GENERAL PROJECT REPORT
2310 INTERSTATE COMMERCIAL PARK

REVIEW COMMENTS

FILE #175-94

TITLE HEADING: Site Plan Review - Office/
Warehouse

PLOT PLAN 1" = 20'-0"

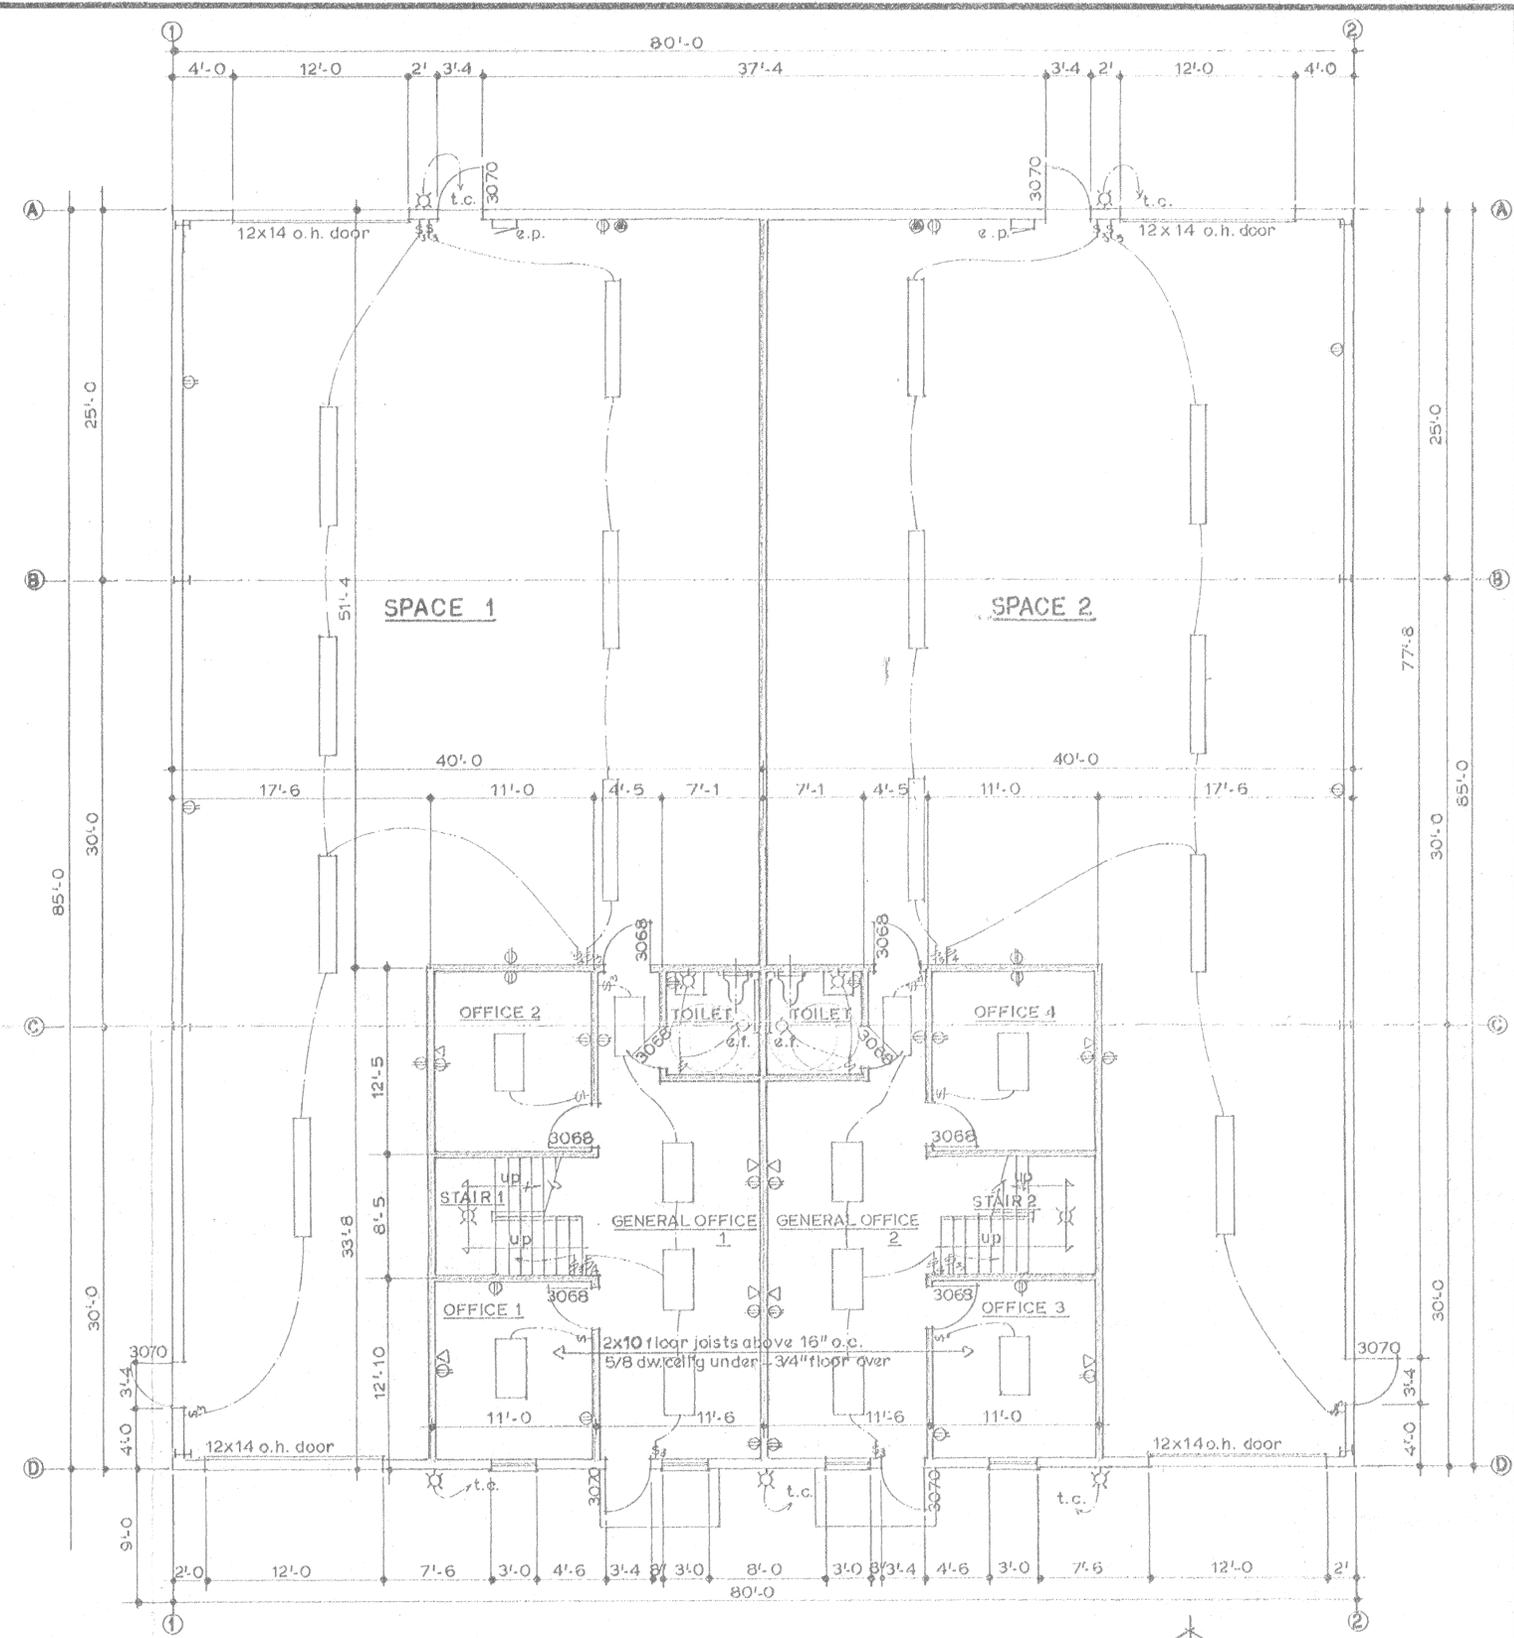
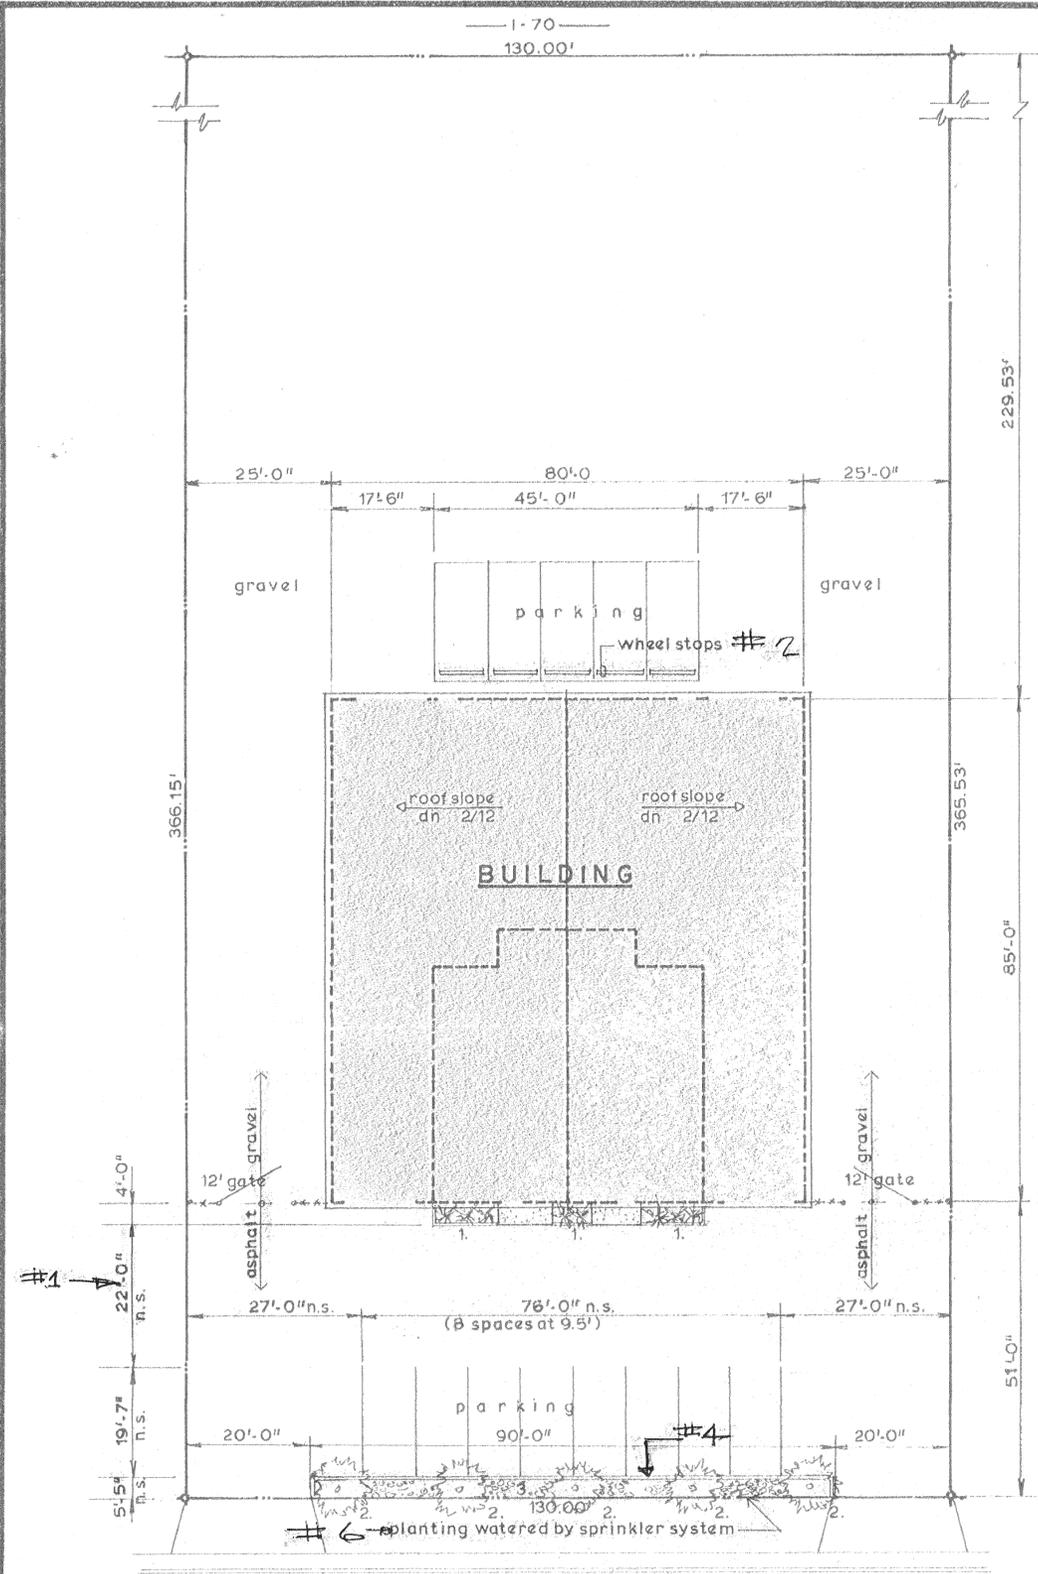
1. Drainage Fee - \$2,230.58.
2. Show extent of paving.
3. Driveways must be constructed in accordance with City standard drawing.
4. ← Transportation Capacity Payment - \$1,659.20
5. The parking aisle width is not wide enough where the planters are in front of the building.

1. The aisle width provided along the front of the building is only 22 ft. wide. City requirements call for a minimum 22 foot aisle width where parking spaces measure 9.5 ft. by 18.5 ft.

2. The parking spaces to the rear of the building shall be delineated with bumper blocks if a gravel surface is provided.
3. Landscaping along roadway does not meet the minimum prescribed by ordinance. Section 4-2-15 requires that a minimum of 75% of the first five feet along the street be landscaped. This calculates to 488 square feet whereas only 255 sq. ft. of landscaping is provided. The building and/or parking may need to be relocated further to the rear of the site to accommodate the required landscaping.

4. All landscaping should be protected by curbing. Landscape islands should be at least five feet deep; narrow islands are a maintenance problem. The proposed street frontage landscaping should be protected by bumper blocks if no overhang area in the landscaped island is proposed.

5. Rock ground covers (as proposed) absorb heat and may decrease plant survival rates. The petitioner should consider an alternative ground cover.
6. Section 5-4-15.D of the Code requires an underground, pressurized irrigation system for all landscaped areas. This should be noted on the plans.

plants:
1. pfitzer - 3 gal.
2. elm - 1 1/2 at 6"
3. tan bark on wood chip
required area: 130 x 0.75 x 5 = 487.5 sq. ft. #3
area shown: 90 x 5.417 = 487.5 s. f.
